Change/Errata Information

Title: MODEL 515A PORTABLE CALIBRATOR
Print Date: DECEMBER 1974
Rev and Date: 2 - 11/75

CHANGE #1 – 8958

Rev. -B, Battery Pack PCB Assembly

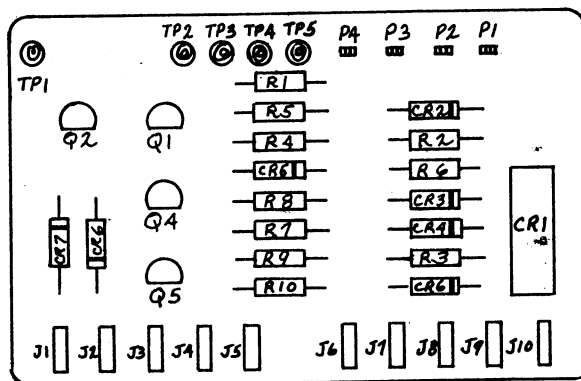
On page 5-21, replace Figure 5-7, with the following:

On page 8-4, Figure 8-2, make the following changes:

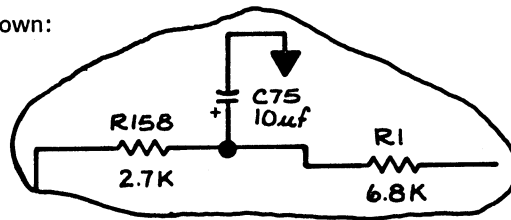
On page 8-3, make the following changes to Figure 8-1:

Add C75 and R158 as shown:
